Product Change Notice (PCN)

PCN Number: PCN-0365225R-01

Product(s) Affected: SDI36-U & SDI35-UD Series

Current

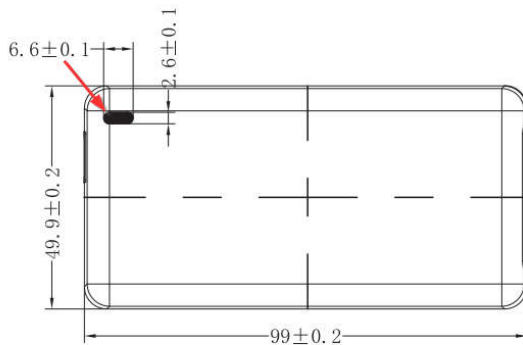
Reason(s) for Change: LED lens case tool update.

Description of Change: Size of LED lens shortened for concentrated light signal.

Additional Information: No change to fit or function. Form has been changed.
